LR-N15-0118

Salem Nuclear Generating Station Unit 2
Renewed Facility Operating License No. DPR-75
NRC Docket No. 50-311

SUBJECT: Response to Salem Nuclear Generating Station, Unit 2, Request for Additional Information Re: Spring 2014 Steam Generator Tube Inspections (TAC No. MF5117)

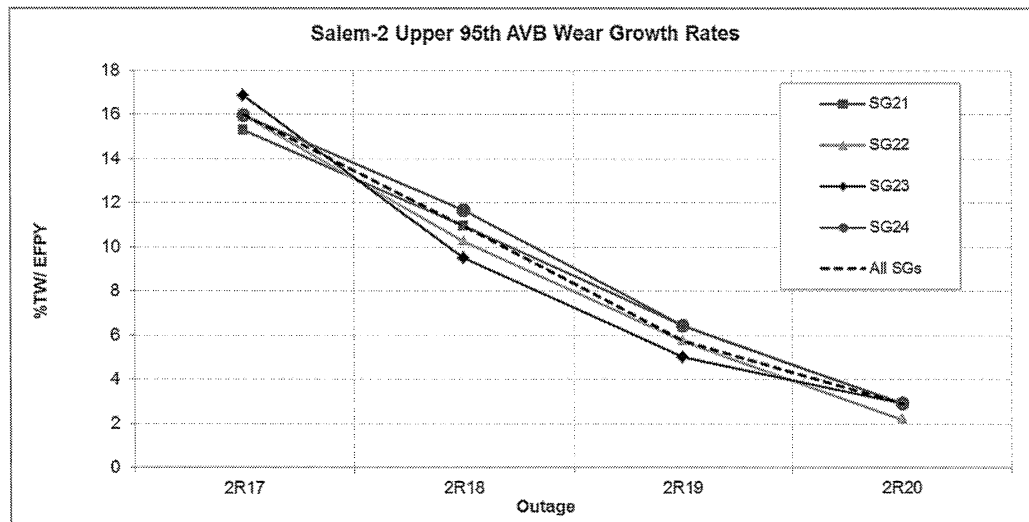
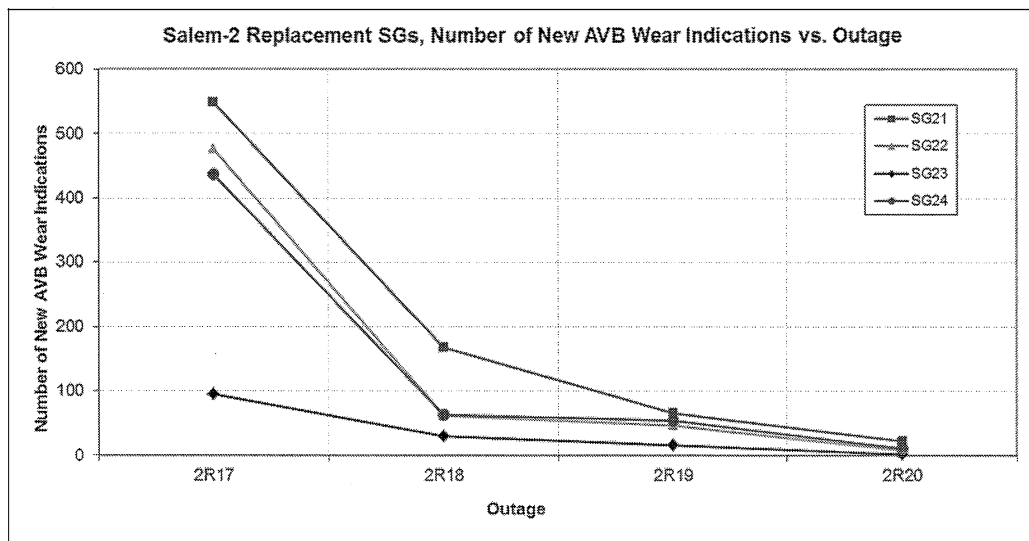
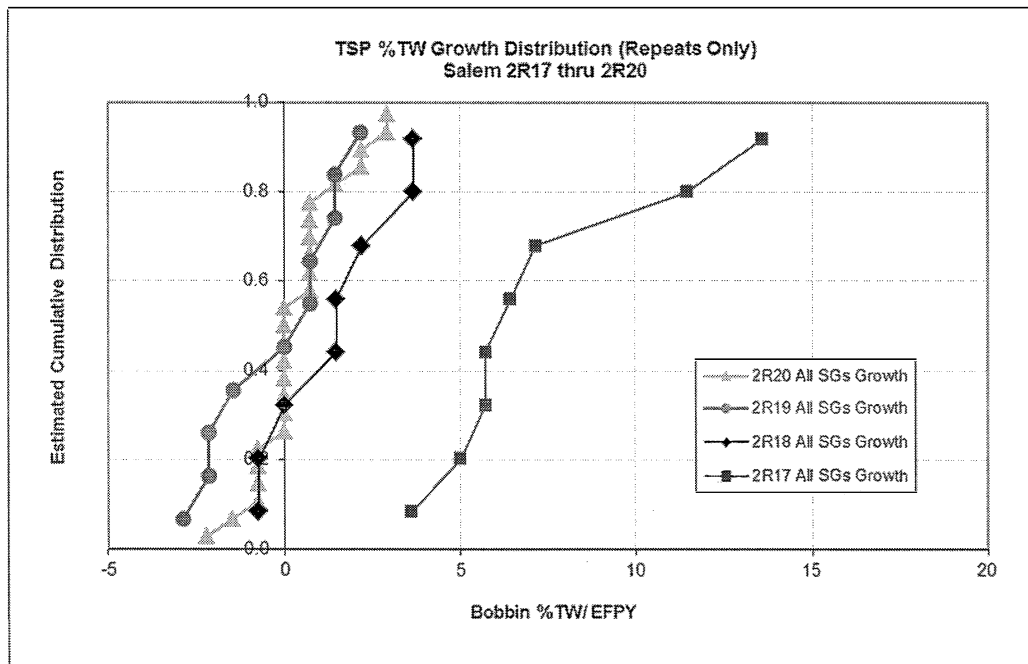
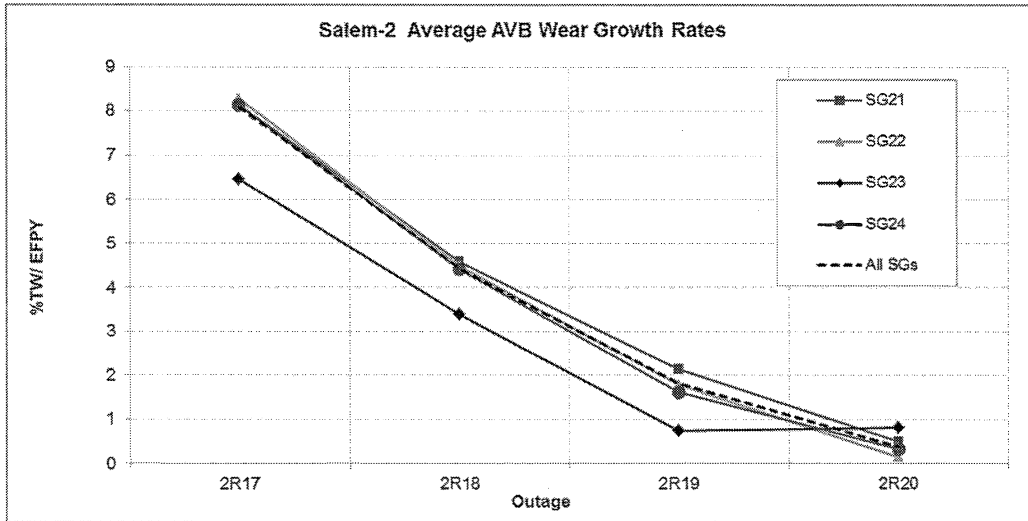
3. Please summarize the number of indications and tubes with wear at the anti-vibration bars. Please summarize the number of indications and tubes with wear at the tube support plates (TSPs). Please discuss whether the number of new wear indications and wear growth rates have continued to decrease from RFO 19 to RFO 20, for both anti-vibration bar and TSP wear.

Below is a table summarizing the bobbin eddy current inspection results for the number of indications and tubes with wear at the anti-vibration bars (AVB) and tube support plates (TSP), and four graphs representing the trends for the number of new anti-vibration bar wear indications, AVB wear growth rates, and TSP wear growth rates. The growth rate graphs provide the trends with the upper 95th percentile growth rate and the average growth rate for AVB wear indications with history (with exception of 2R17, since all indications in 2R17 are new). As shown in these graphs, the trends for the number of new anti-vibration bar wear indications, AVB wear growth rates, and TSP wear growth rates at each inspection outage have continued to decline with each inspection outage; or have essentially no change (i.e. – stabilized). The number of TSP wear indications returned to service following outage 2R19 was 24 (Attachment 2 of LR-N14-0009, ML14010A428). During outage 2R20, 35 bobbin TSP wear indications were reported (one additional bobbin indication was reported as a Distorted Support Indication (DSI) bringing the bobbin indication total to 36). The overall population of TSP wear indications is limited and relatively small, with a change of 12 new TSP wear indications detected by eddy current bobbin inspection during outage 2R20. Subsequent to outage 2R20 tube plugging, 24 bobbin TSP wear indications were returned to service.
